**ADDENDUM NUMBER ONE
SECTION 00 91 13 (A)**

**PROJECT: REPLACE HAIL-DAMAGED ROOFS
JACKSON, HINDS COUNTY, MISSISSIPPI**

**PROJECT NUMBER: MEP-5000-25(080) 502884
MEP-5000-25(088) 502884**

WORKING NUMBER
A1.3-AD
 SHEET NUMBER
6

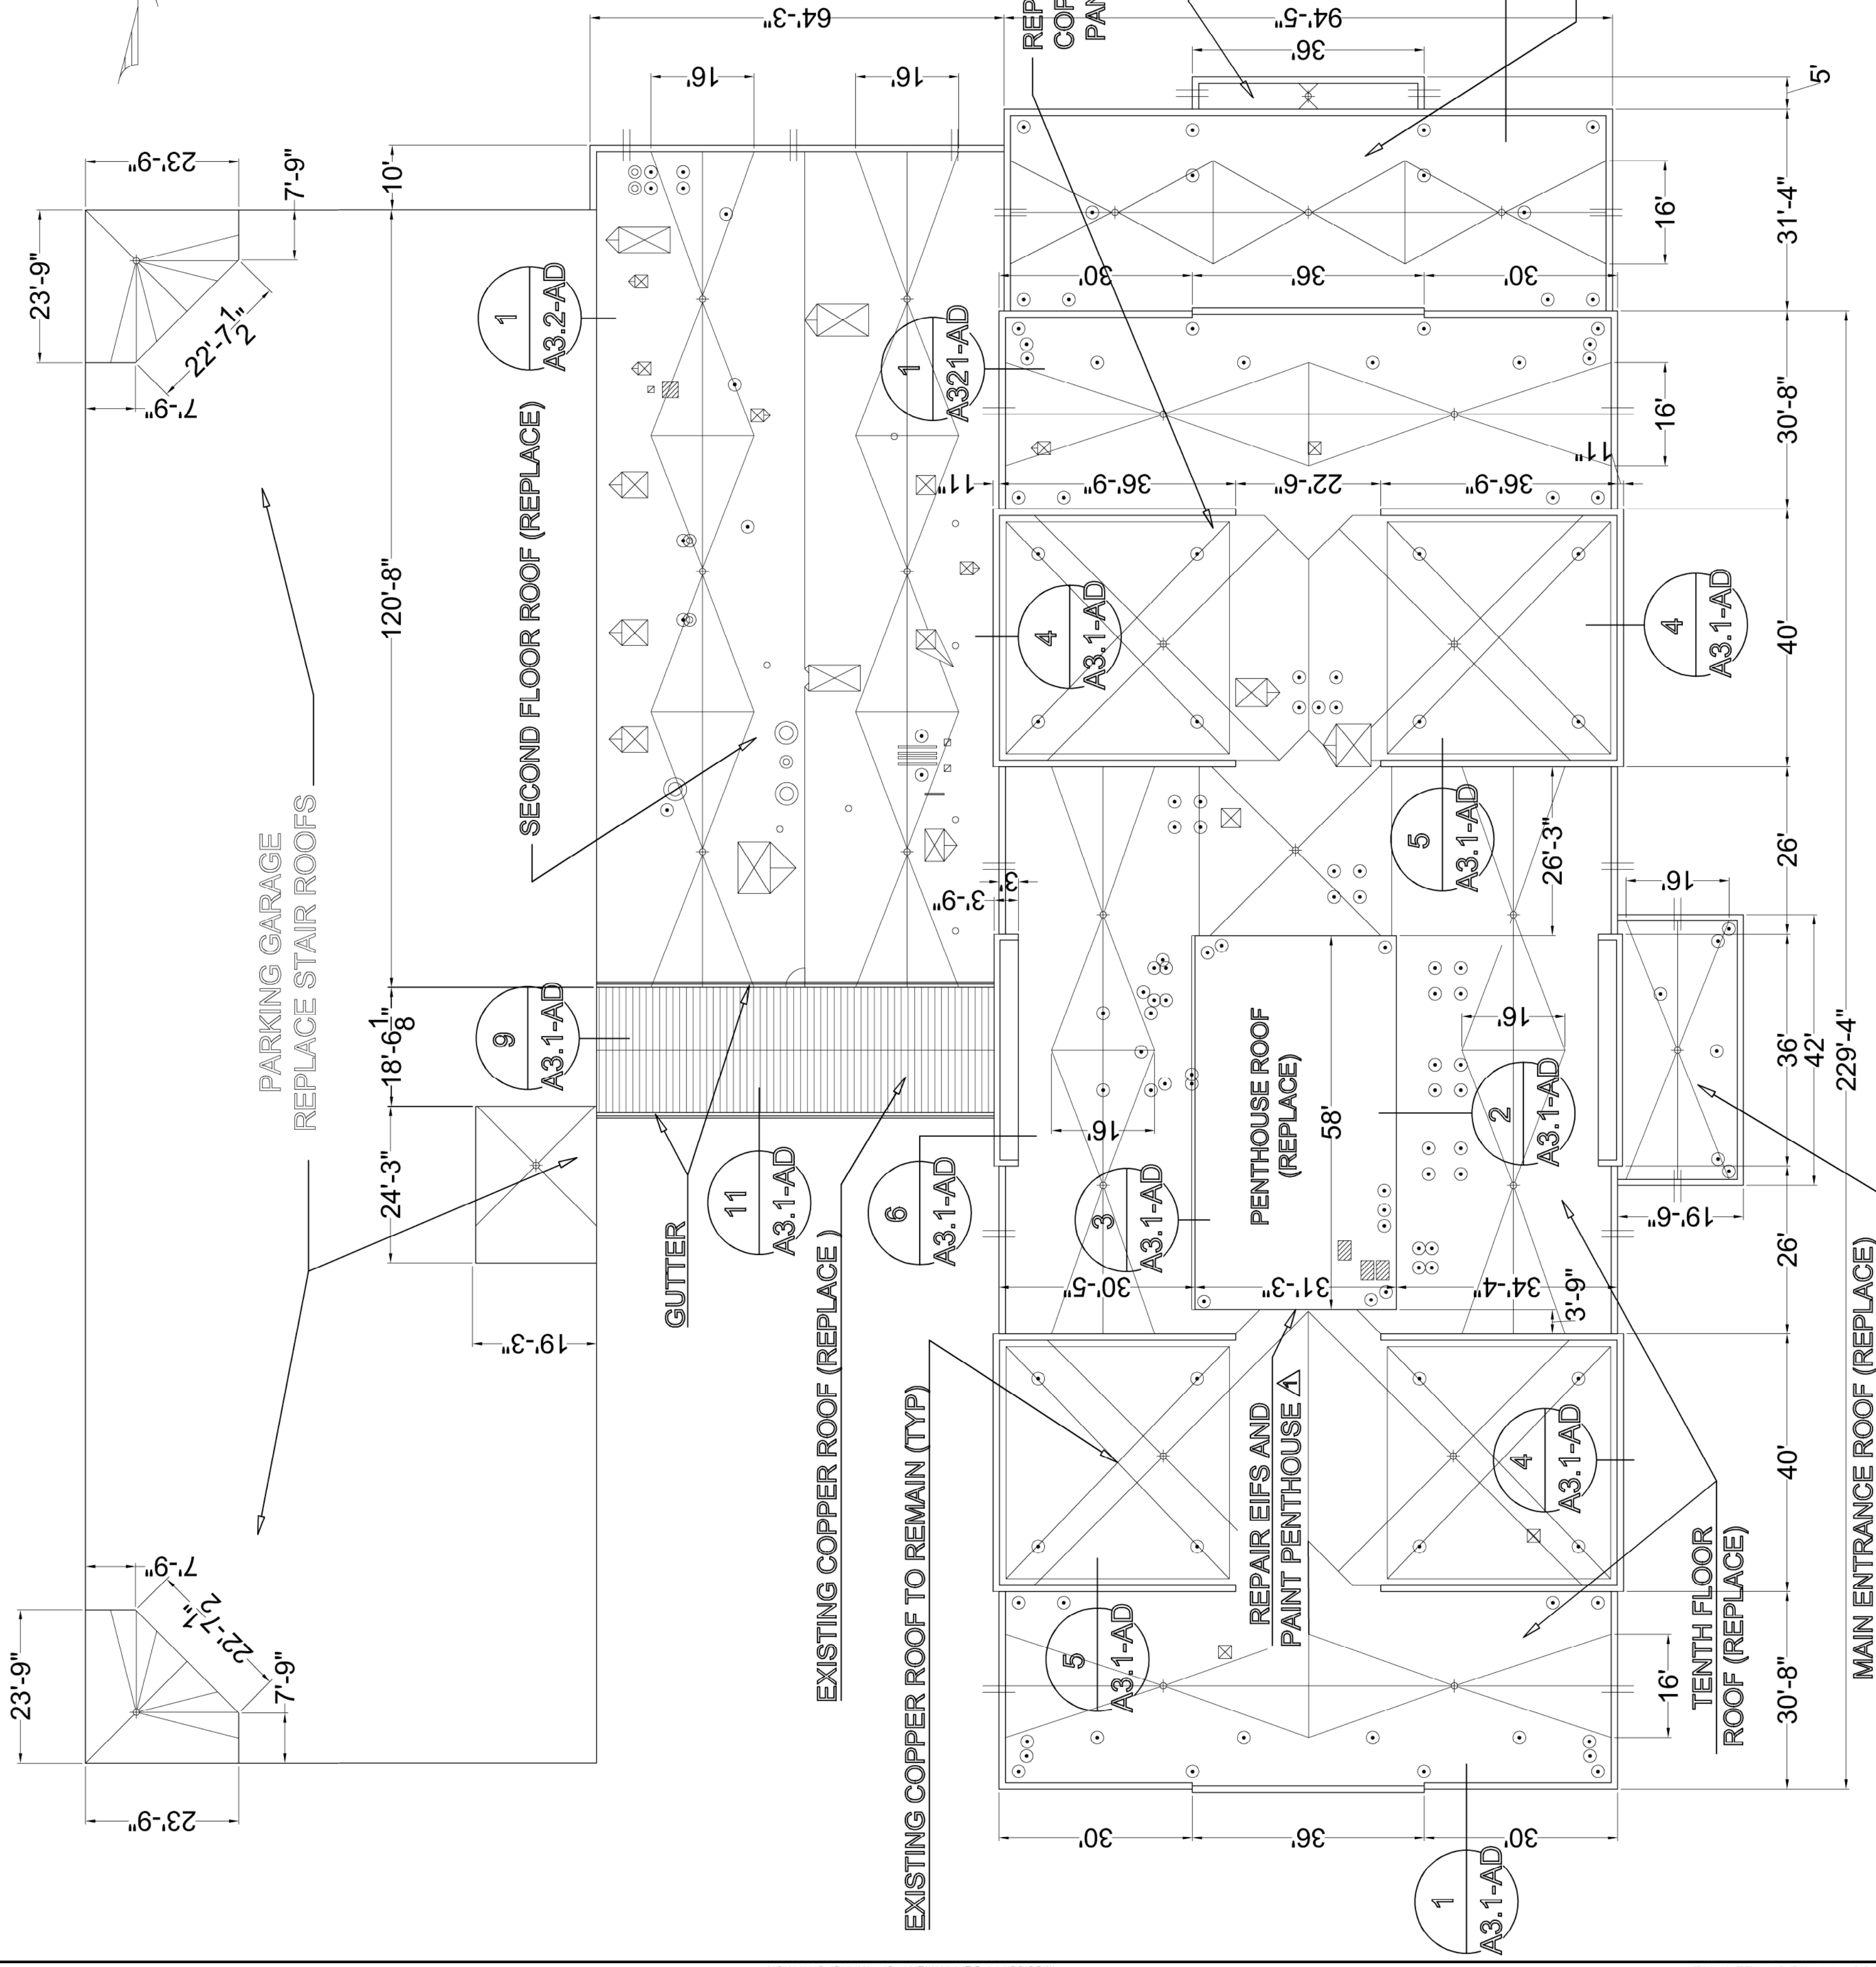
| 5/14/15 | DSM | ADD NOTE |

| | | 10 |

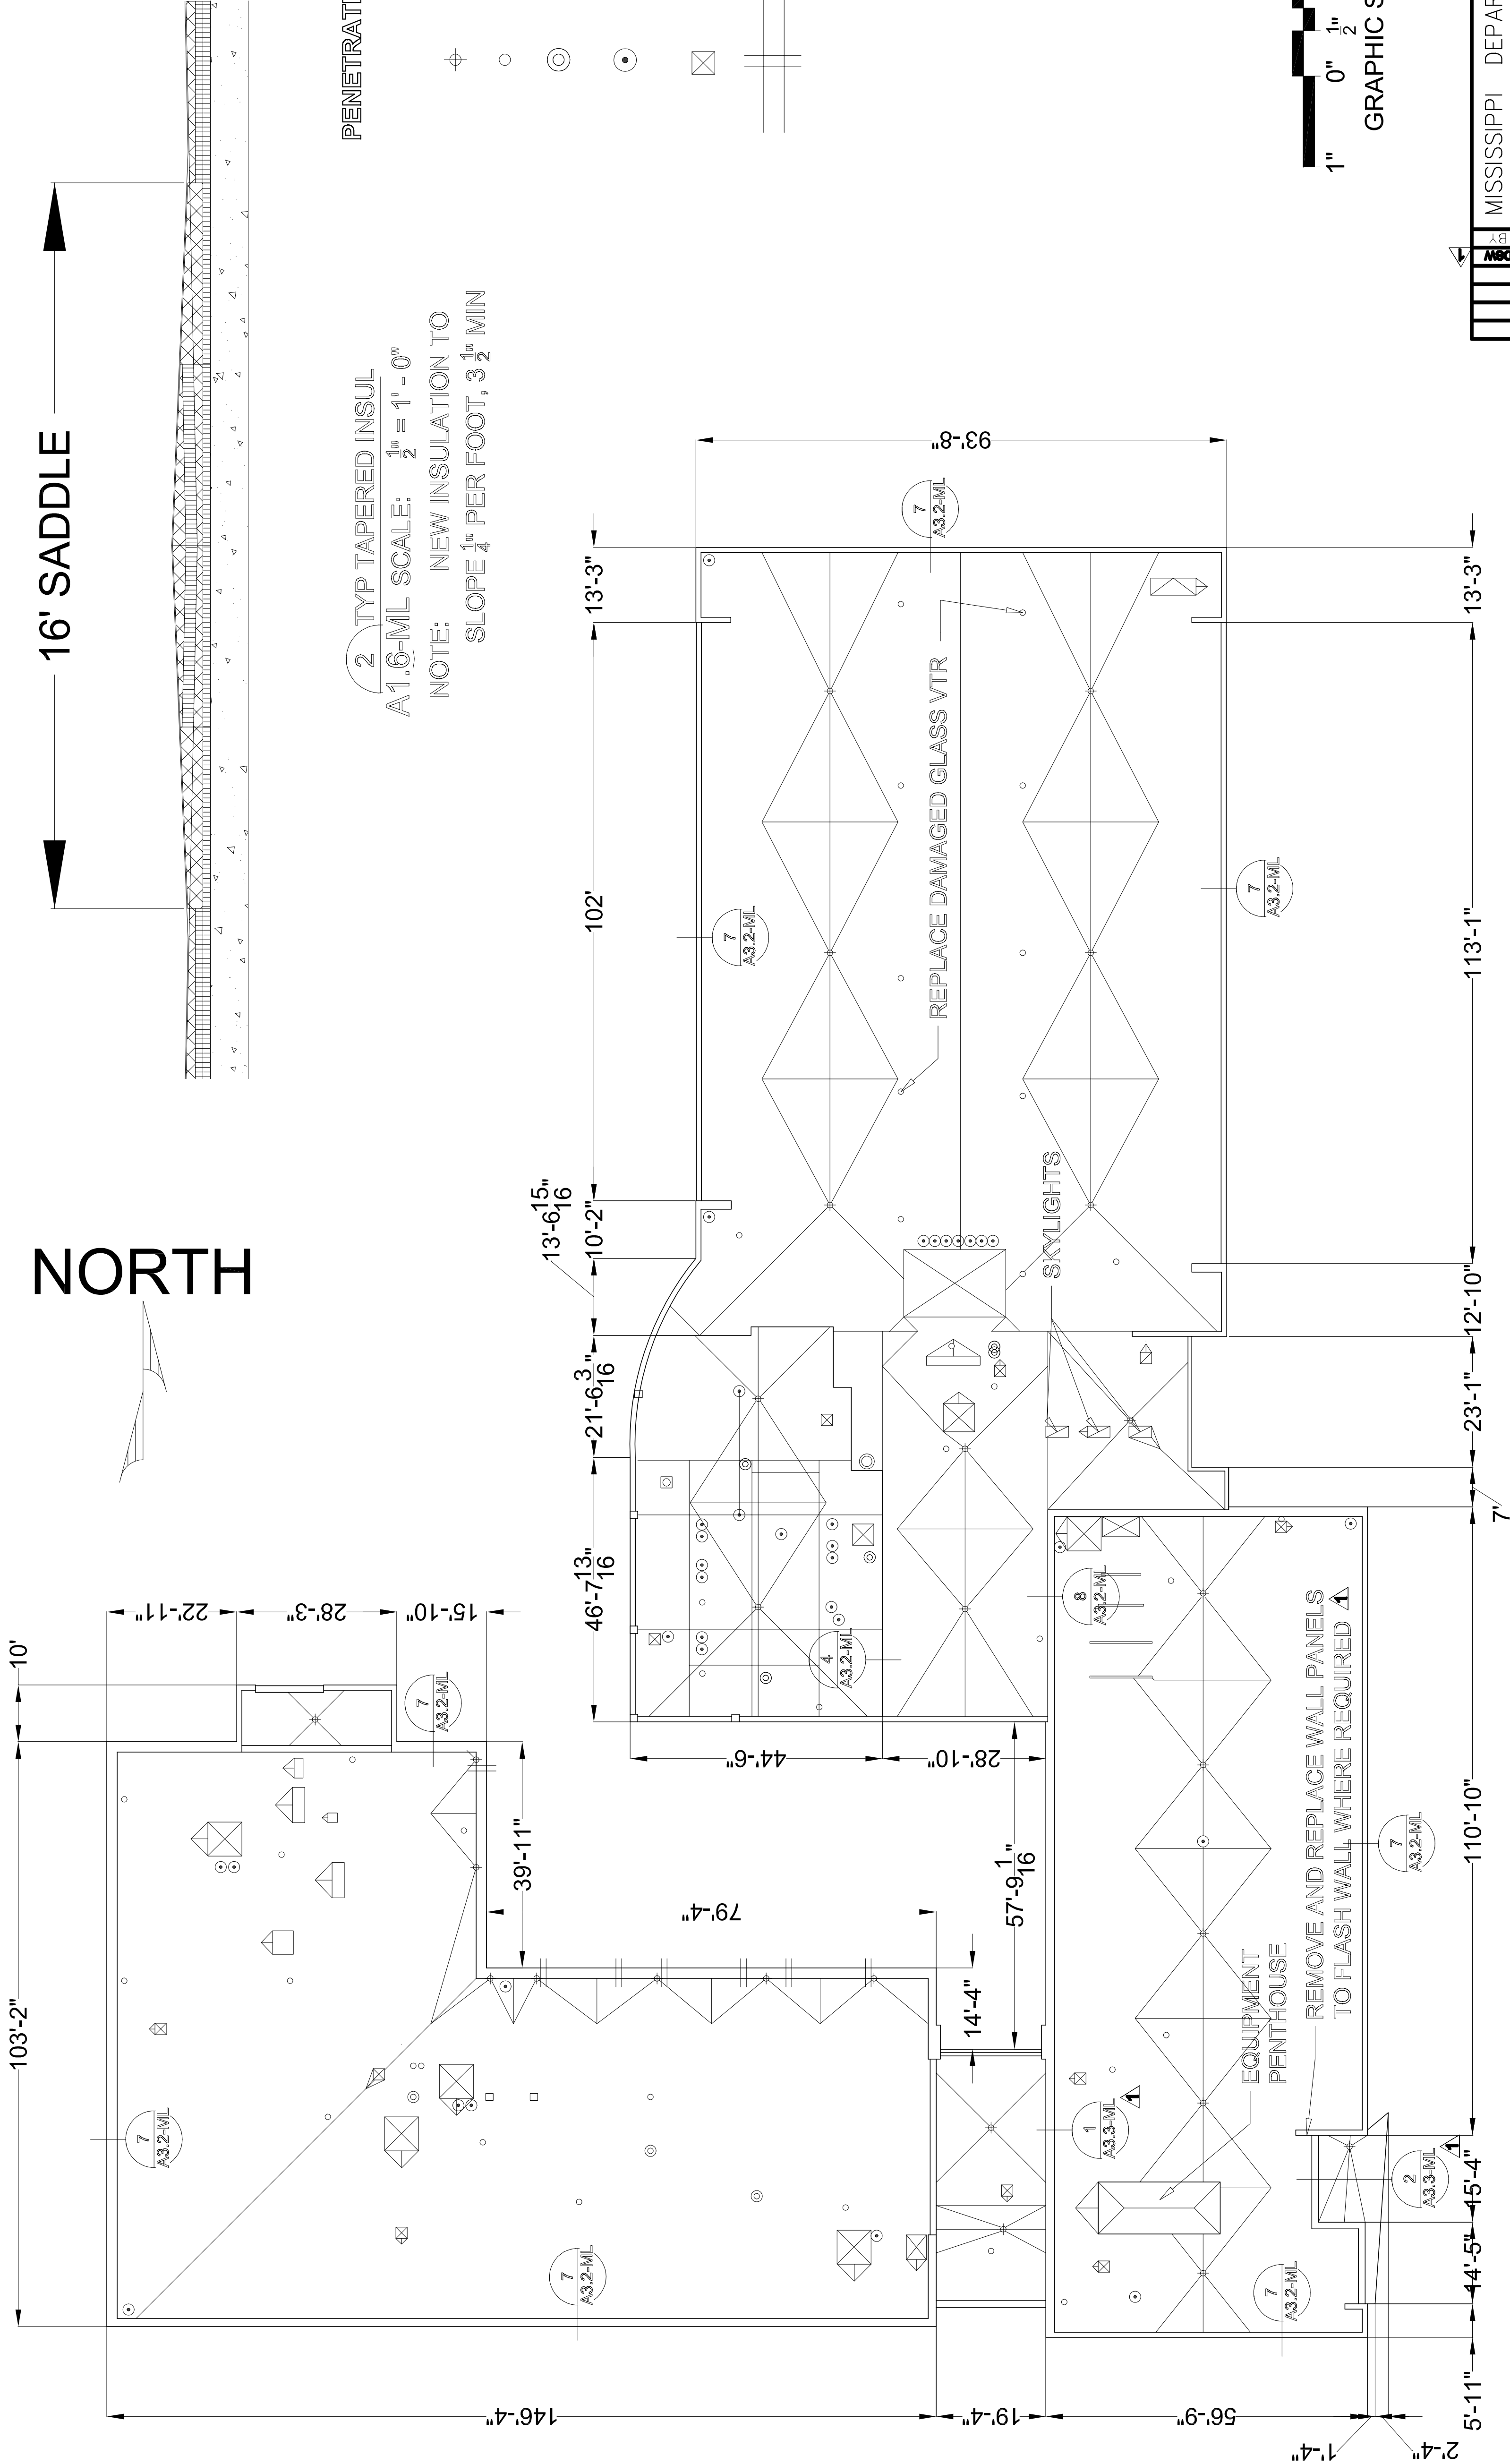
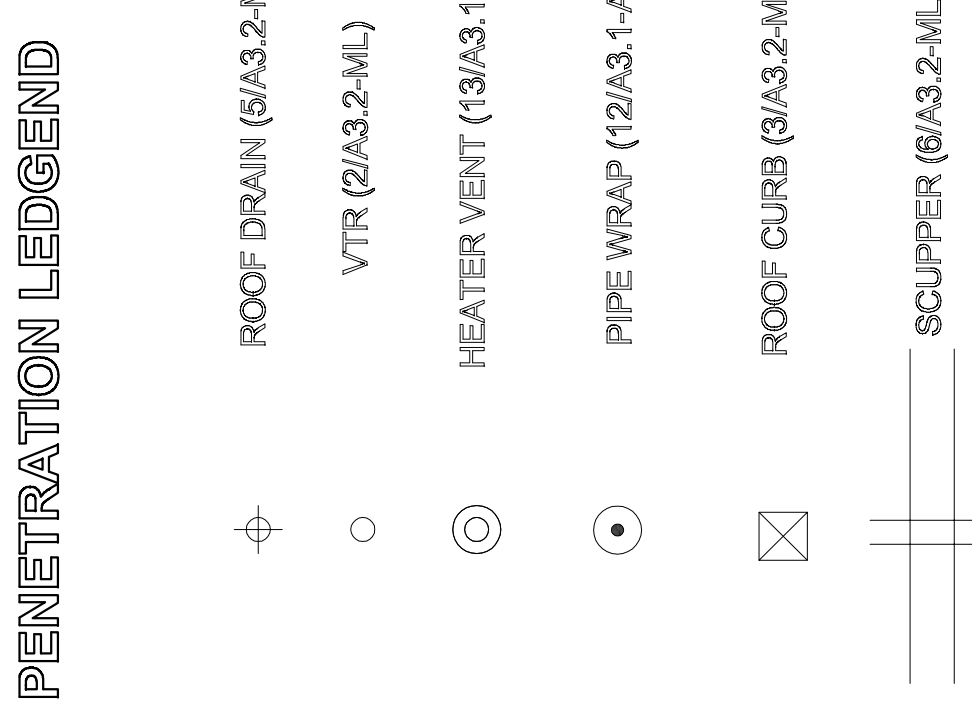
| ADD DETAIL AND NOTE | | |
